CONSTRUCTION PLANS
FOR
THE RIDGE AT LORSON RANCH FILING NO. 1
STREET & STORM SEWER CONSTRUCTION PLANS

THE RIDGE AT LORSON RANCH FILING NO. 1
STREET / STORM SEWER
CONSTRUCTION PLANS

DATE: MARCH, 2022
PROJECT NO. 100.066
SHEET NUMBER C1.1
TOTAL SHEETS: 51

DATE: MARCH, 2022
 PROJECT NO. 100.066
 SHEET NUMBER C5.4
 TOTAL SHEETS: 51

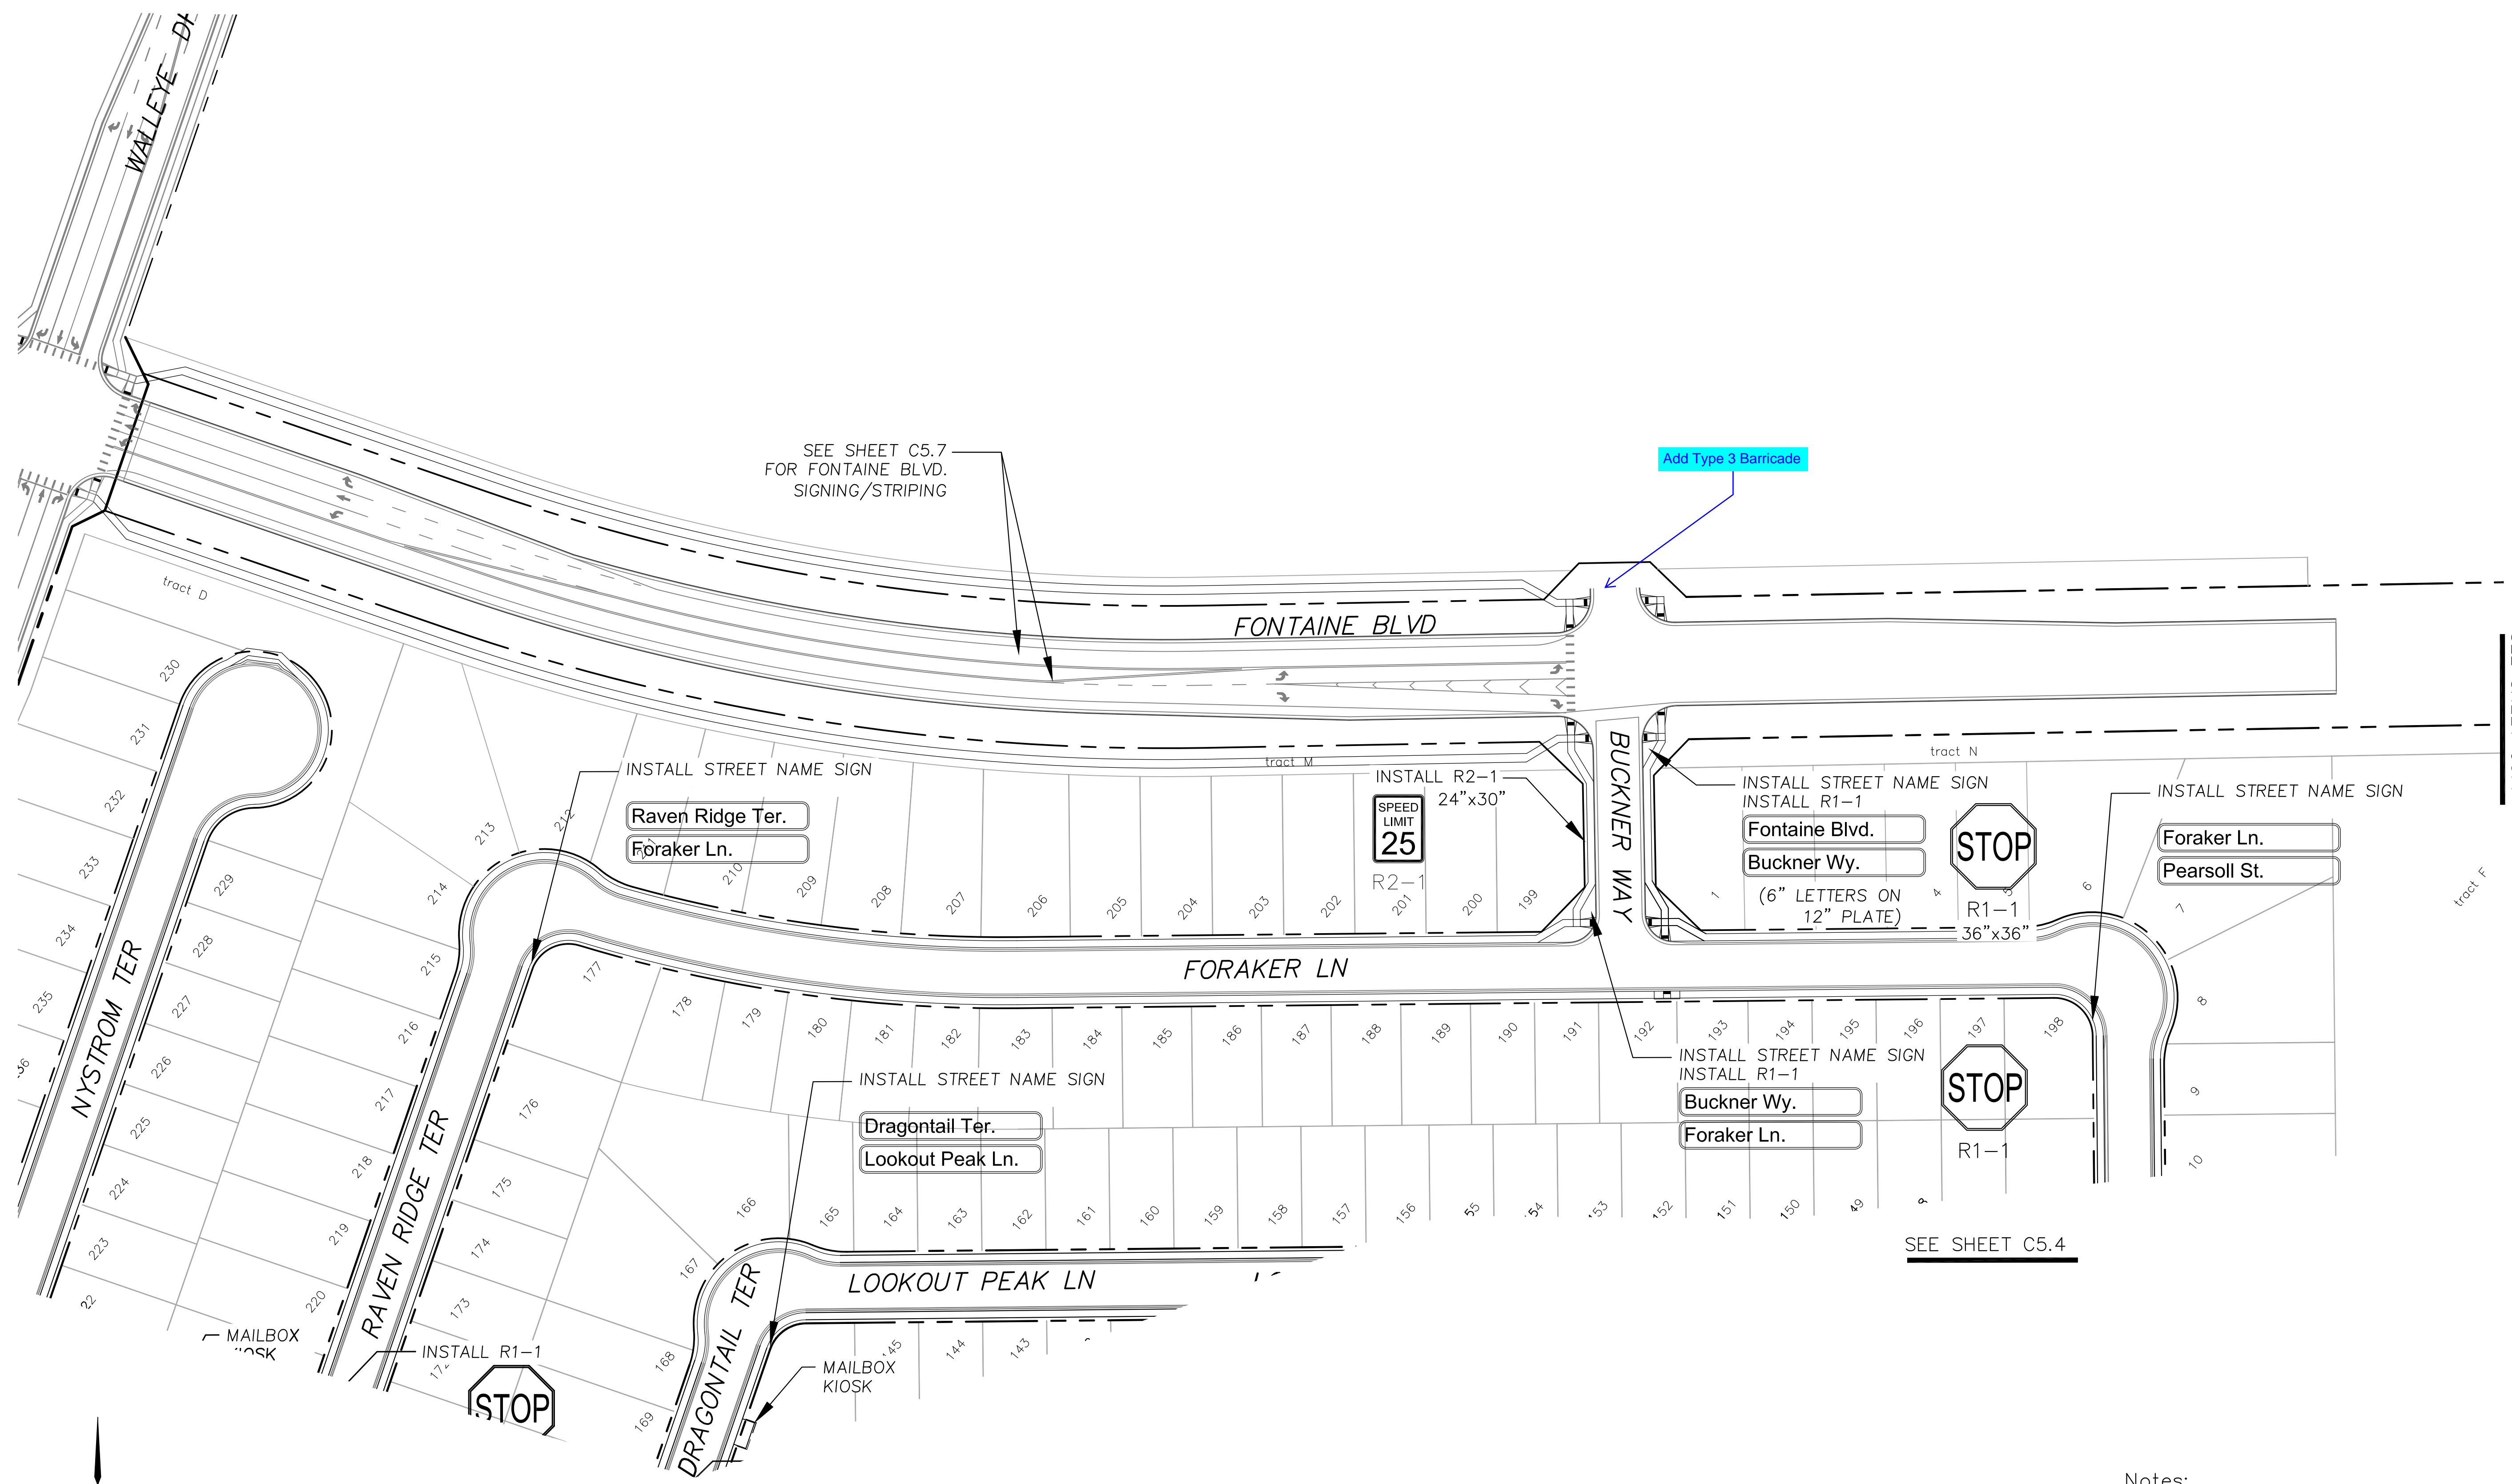
Add Type 3 Barricade

DATE: MARCH, 2022
 PROJECT NO. 100.066
 SHEET NUMBER C6.2
 TOTAL SHEETS: 51

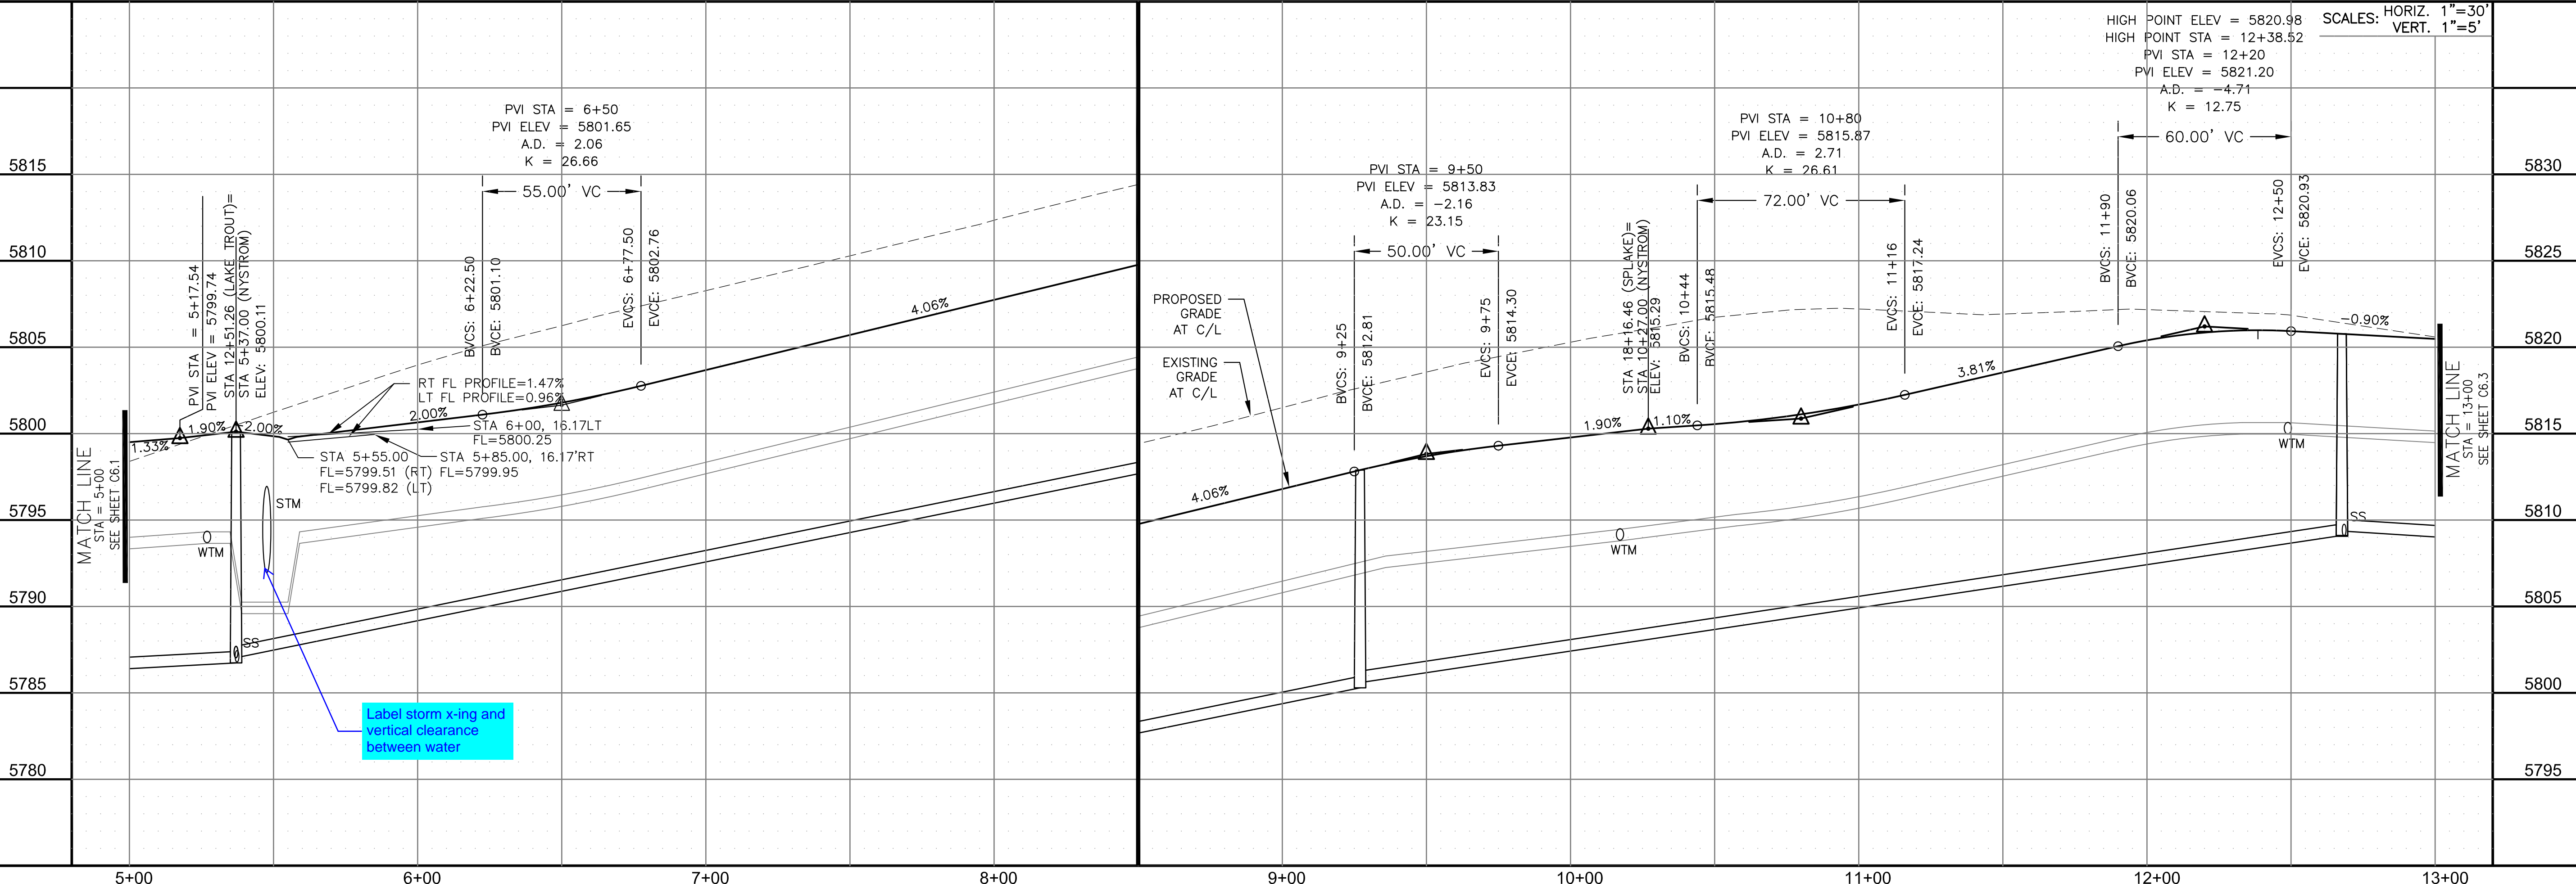
Label storm x-ing and vertical clearance between water

STREET / S M - SOUTH AREA
ASPEN BUTTE TERRACE & SPLAKE ST
STA 33+00 TO 35+89

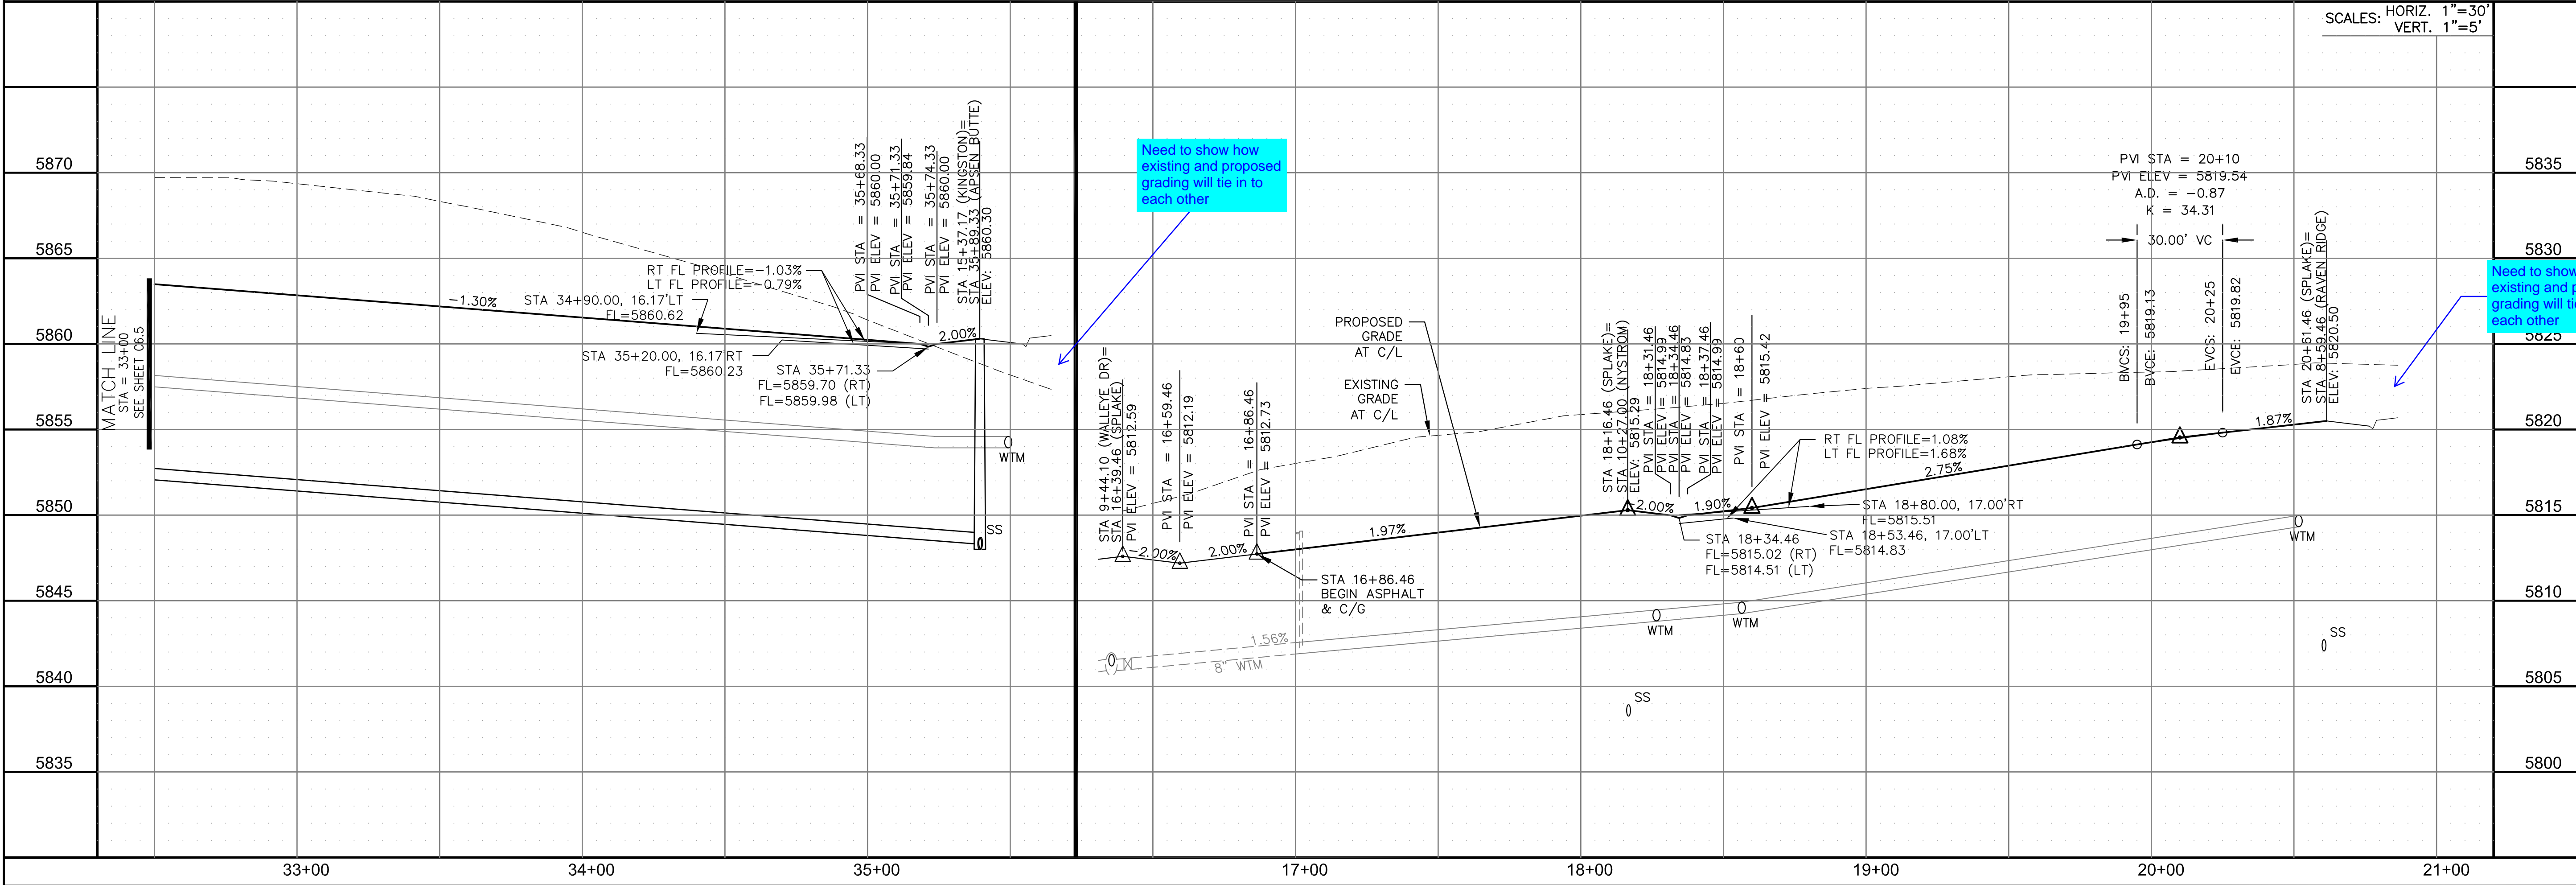
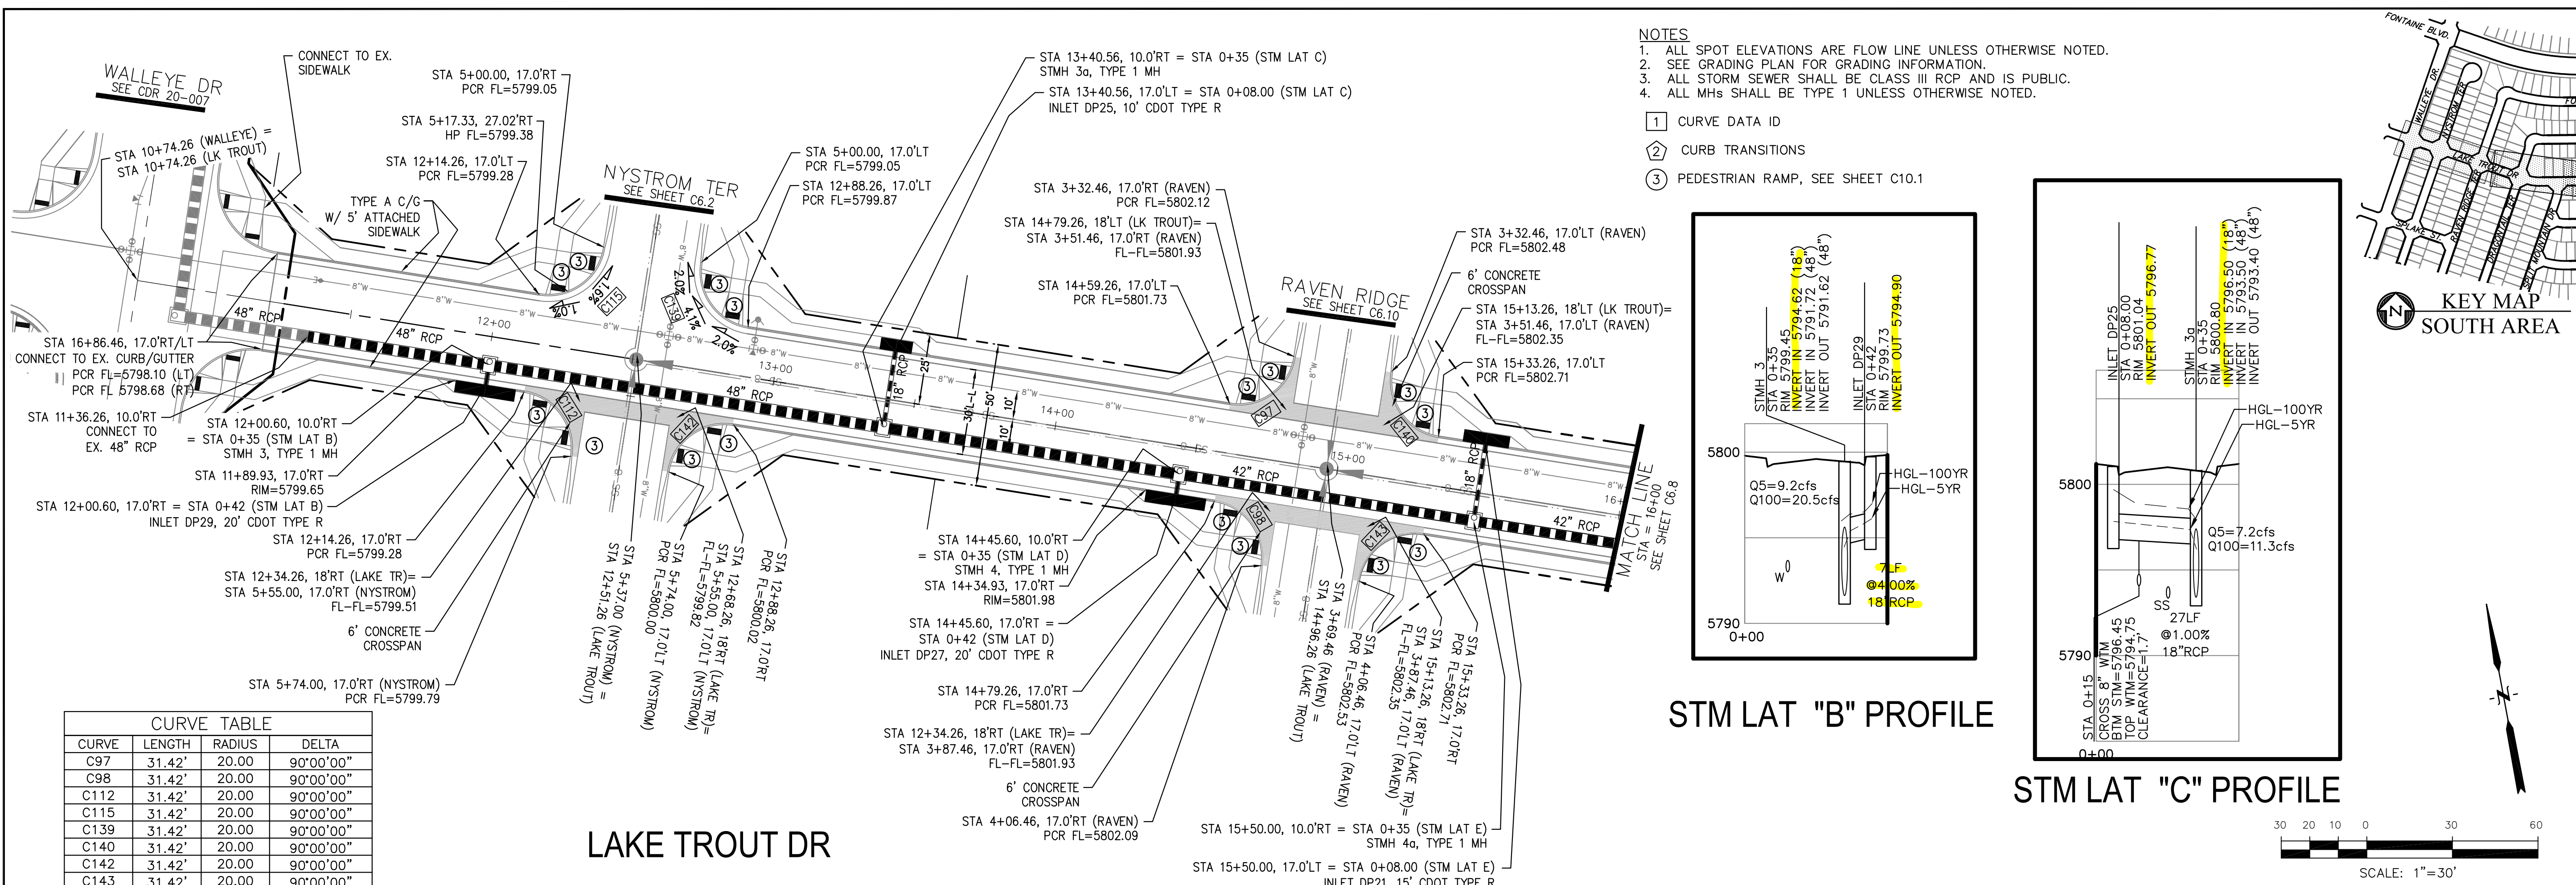
Need to show how existing and proposed grading will tie in to each other

Need to show how existing and proposed grading will tie in to each other
